Young 4 Ever Ltd. (9366)

Plot # B-89-90, BSCIC I/A, Fatullah, Narayangonj.

06.AUGUST.2014

Identified Priority 3 Concerns

2nd Priority 3 Concern

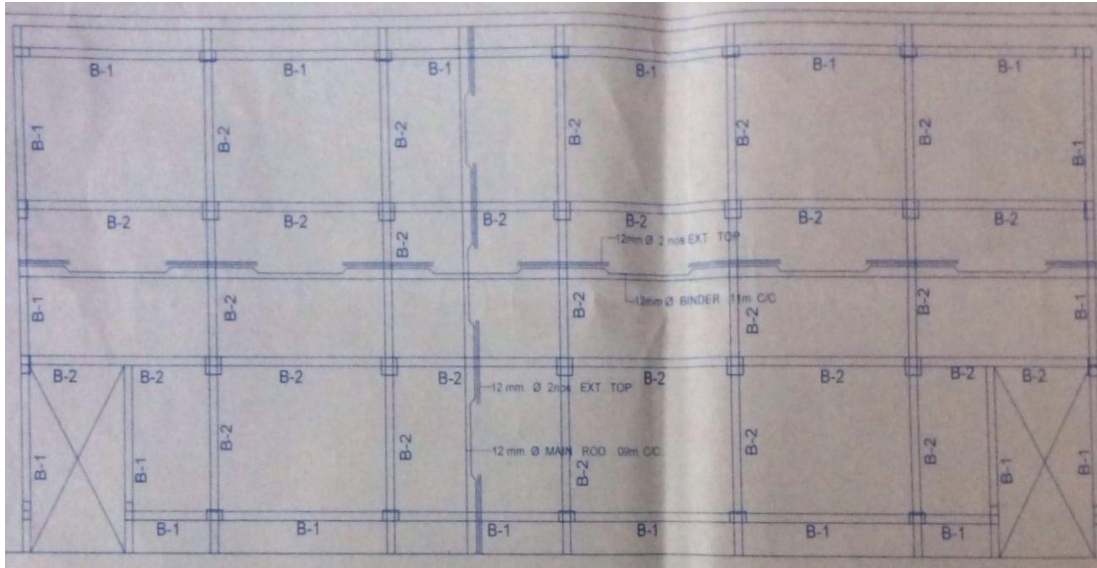
The roof needs an applied water proofing layer.
